STATE OF CONNECTICUT  
CONNECTICUT SITING COUNCIL

APPLICATION OF NEW CINGULAR  
WIRELESS PCS, LLC (AT&T) FOR A  
CERTIFICATE OF ENVIRONMENTAL  
COMPATIBILITY AND PUBLIC NEED  
FOR THE CONSTRUCTION,  
MAINTENANCE AND OPERATION OF  
A TELECOMMUNICATIONS TOWER  
FACILITY AT 27 GUNGY ROAD / 322  
BEAVER BROOK ROAD IN THE  
TOWN OF LYME

DOCKET NO. 381

**AT&T RESPONSE TO SITING COUNCIL INTERROGATORIES**  
**FIRST SET**

# 850 MHz only Coverage from Proposed Site at 160'

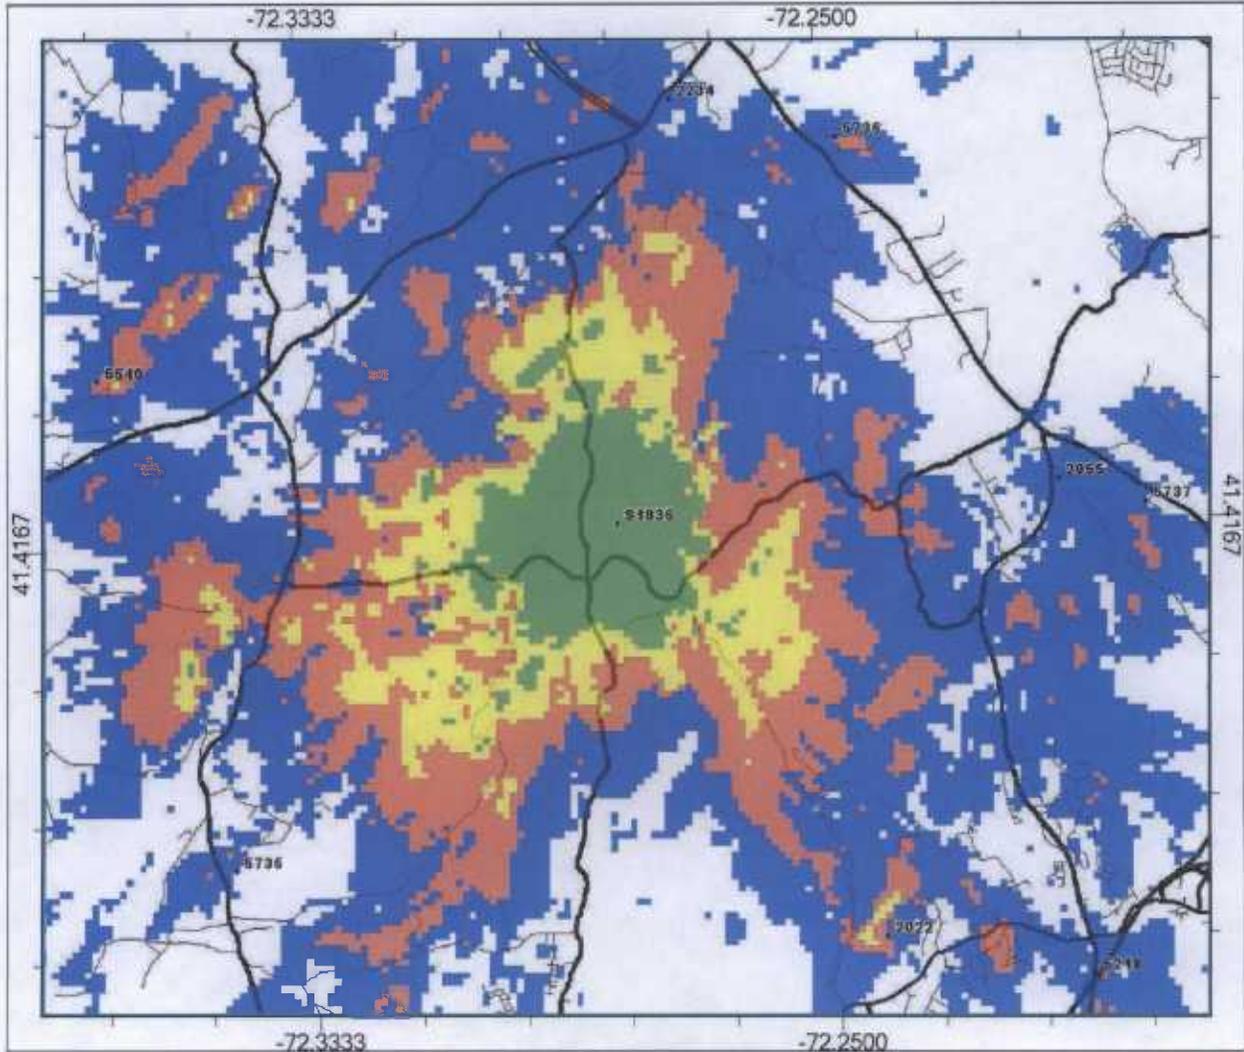
Q14. Provide cellular and PCS coverage plots, as applicable, using the same scale provided assuming the tower is 170 feet tall (with 167 foot antenna centerline height) and 160 feet tall (with 157 feet antenna centerline height), respectively.

A14. Exhibit D includes cellular (850 MHz) and PCS (1900 MHz) coverage plots assuming the tower is 170 feet in height (with an antenna centerline mounting height of 167 feet) and 160 feet in height (with an antenna centerline mounting height of 157 feet), respectively.
